IN THE DRAWINGS

REMARKS

FIG. 6

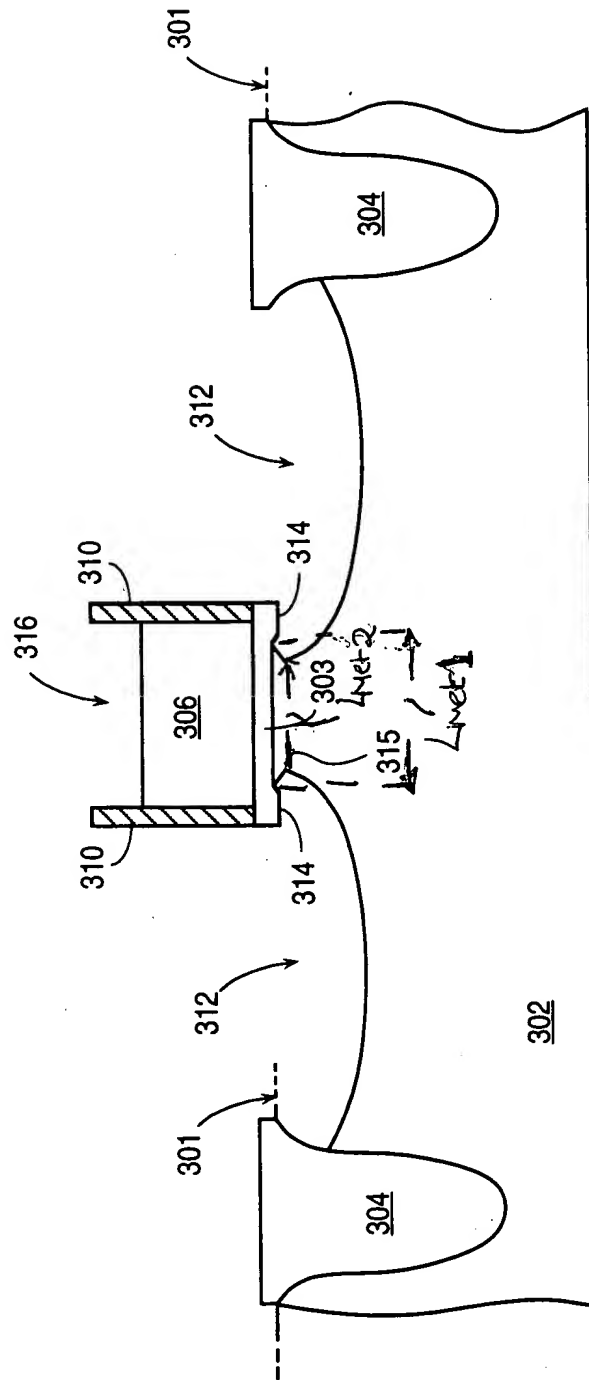
The drawings are objected to as failing to comply with 37 CFR 1.84(p)(5) because they include the following reference character(s) not mentioned in the description: L_{met} . See page 9, lines 10-17.

Applicants submit herewith marked-up copies of drawings with a proposed correction in red, together with replacement drawings, for Figures 2 and 6 to comply with 37 CFR 1.84(p)(5). The amendments to the drawings have been made to include the reference character L_{met} mentioned in the specification in the paragraph on page 6 starting with words "The n-type region 206..." in description of Figure 2, and in the paragraph on page 16 starting with words "Yet another advantage of the lateral recess..." in description of Figure 6.

More specifically, Applicants here have amended drawings for Figures 2 and 6, to include L_{met1} , which denotes a larger physical or metallurgical channel length of the channel region directly beneath the gate dielectric, and L_{met2} , which denotes a smaller physical or metallurgical channel length of the channel region deeper into the substrate between the inflection points, as described in the specification in the above mentioned paragraphs on pages 9 and 16 with respect to Figures 2 and 6 respectively.
